RE: Notice to Bidders
Great Rivers Greenway District
Centennial Greenway Phase IIA
Federal Project Number: TAP-9900(677)
Burns & McDonnell Project Number: 85395
Addendum Number 03

Organizations intending to submit a bid on Centennial Greenway Phase IIA are hereby advised of the following additions and modifications to the bidding documents:

project 85395	contract
drawing C-004	rev. 0

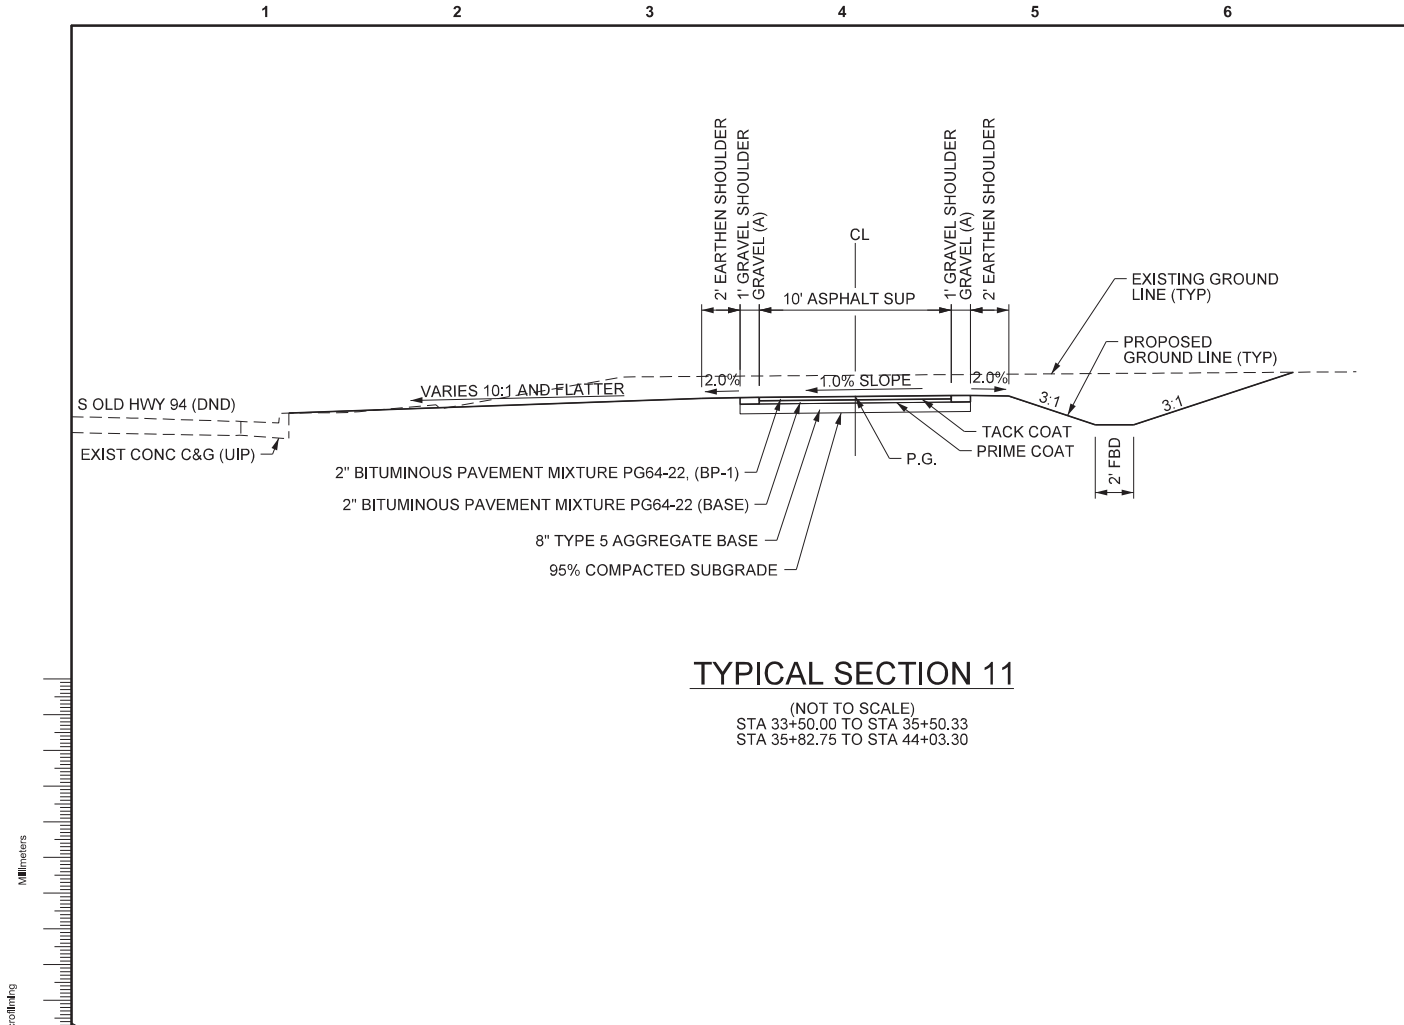
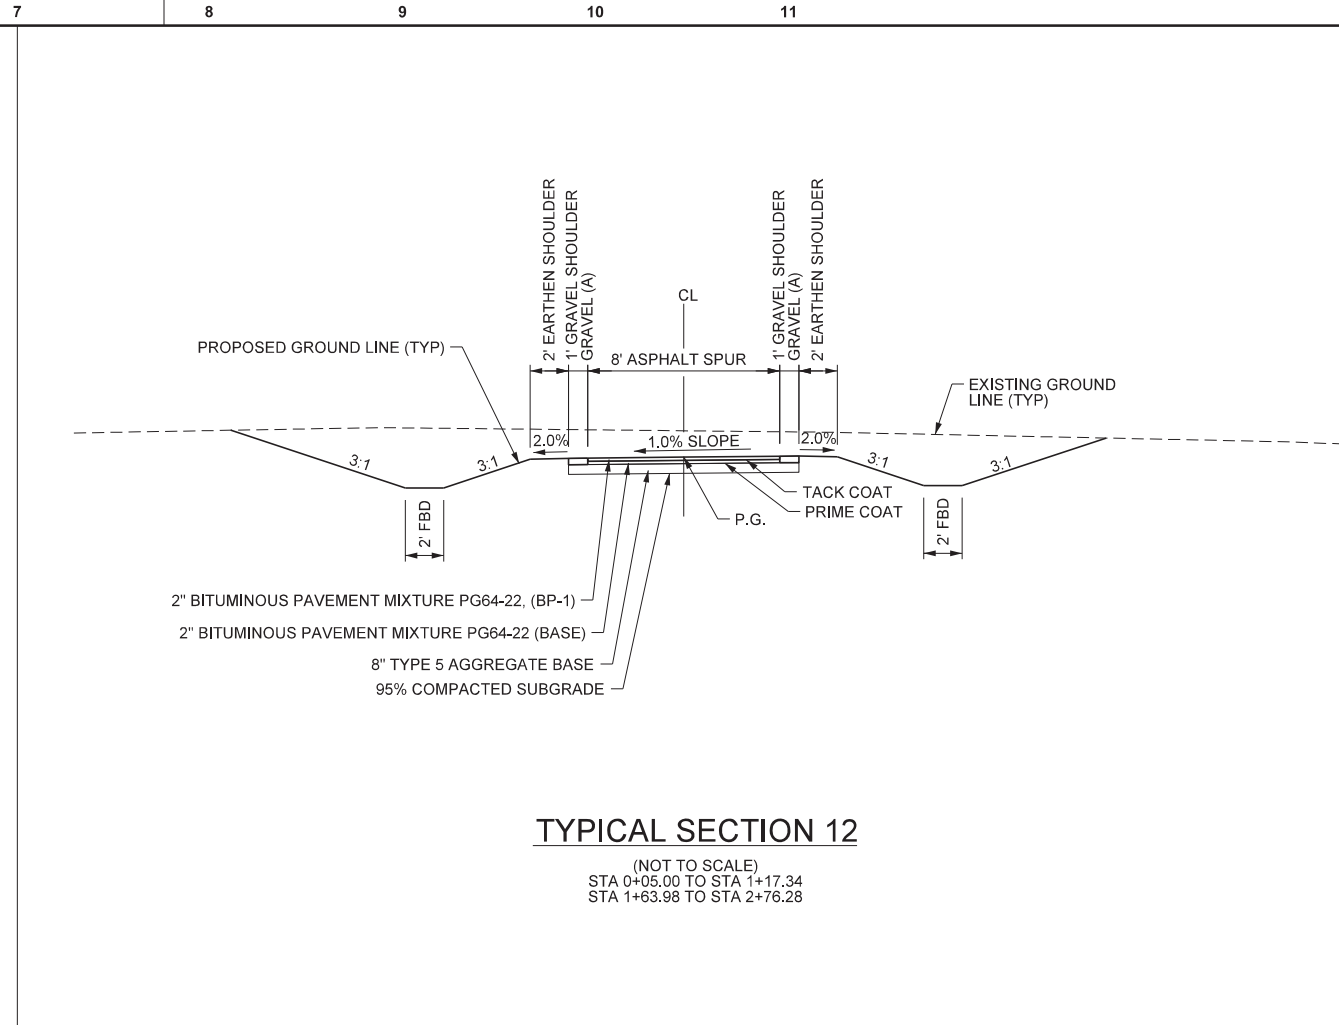
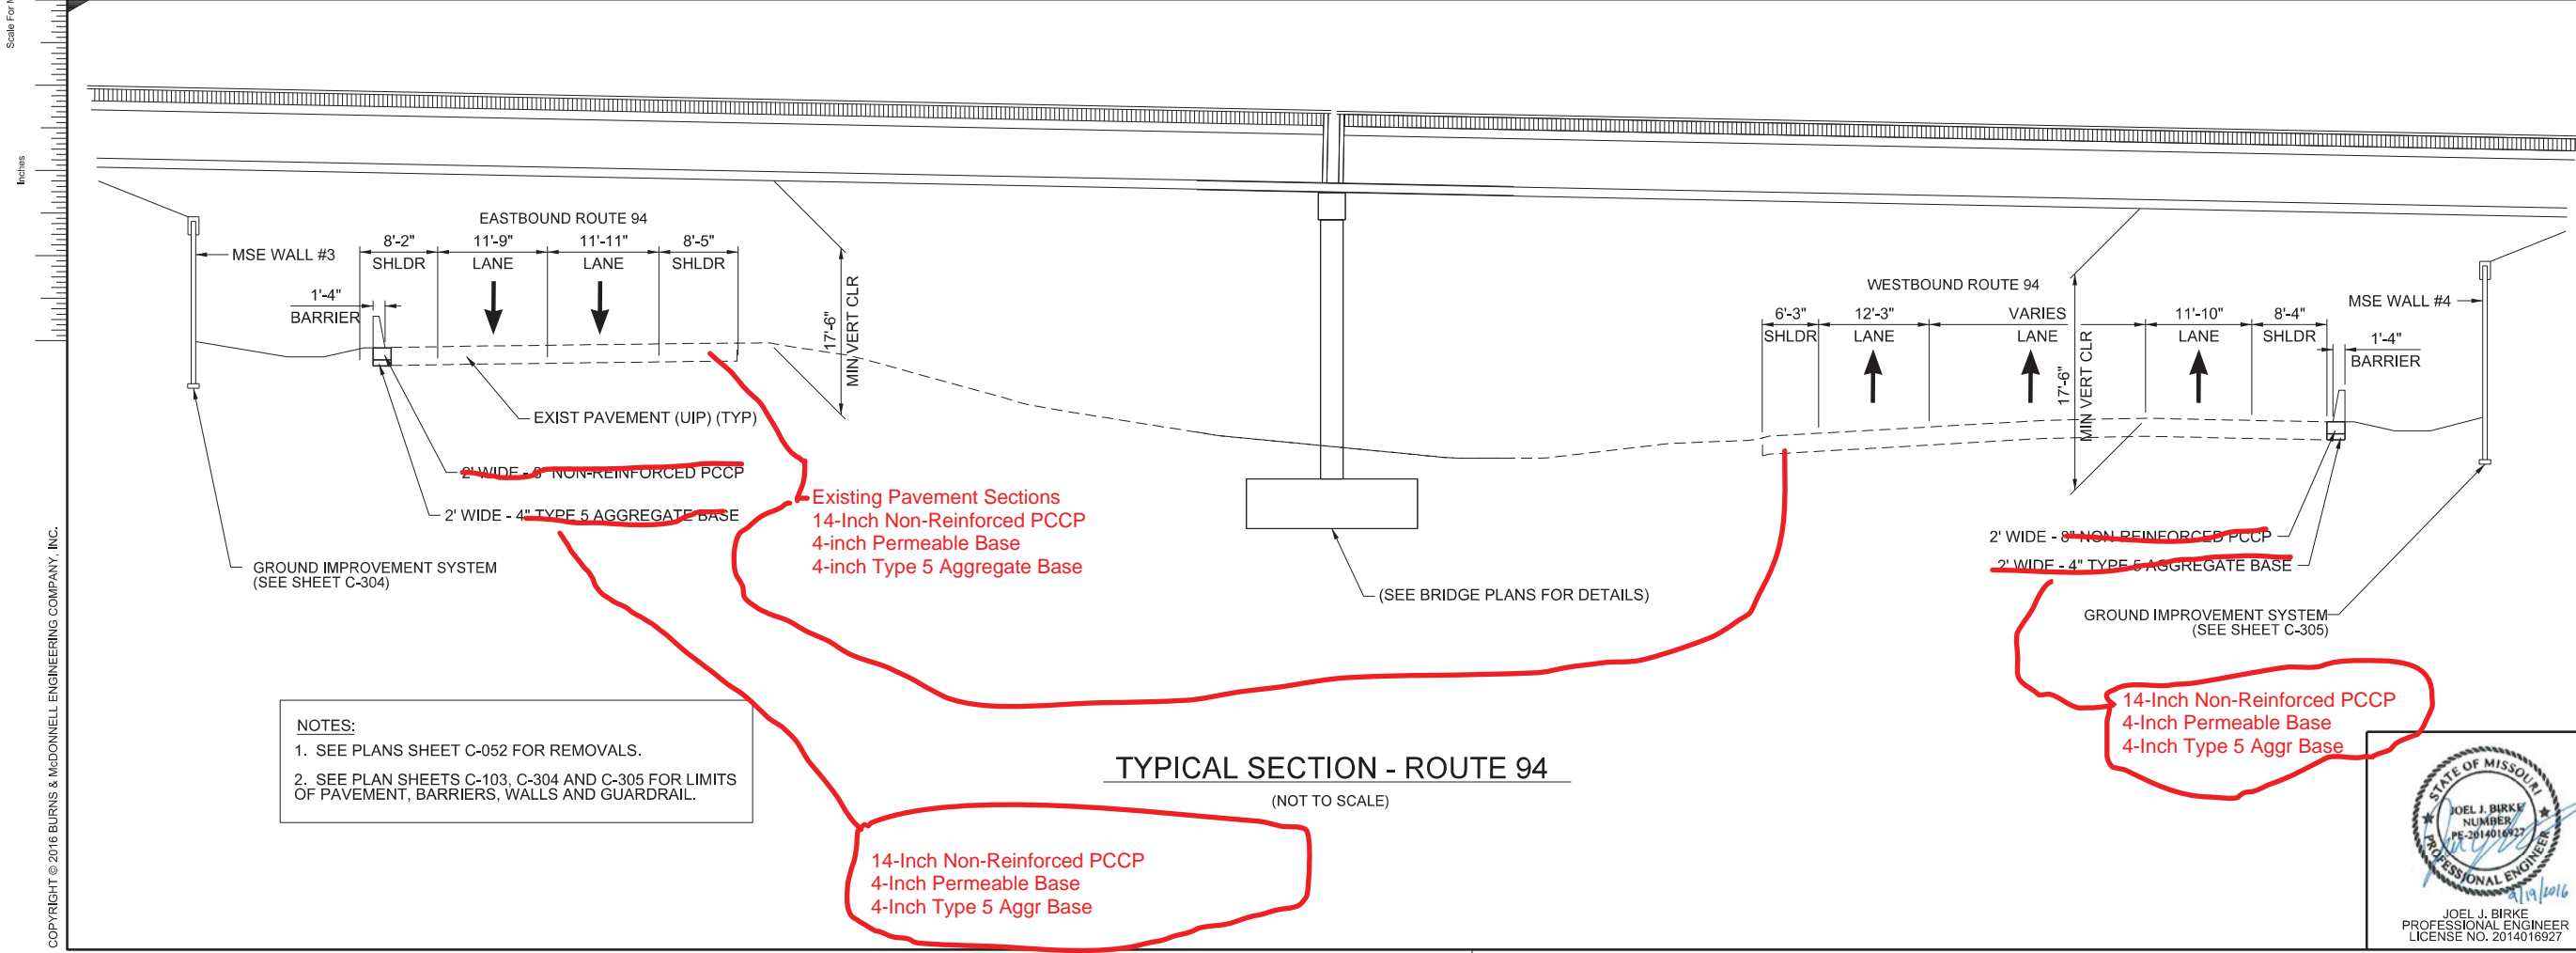
Note: Two new pay items for pavement replacement on MoDOT Routes 364, Route 94 and Ramp are added to project. These two pay items shall replace the 8-inch Non-Reinforced Concrete Pavement. The two new pay items are:

14" Non-Reinforced Concrete Pavement
4" Permeable Base

See updated sheet 2B-1 and typical sections attached to this addendum.
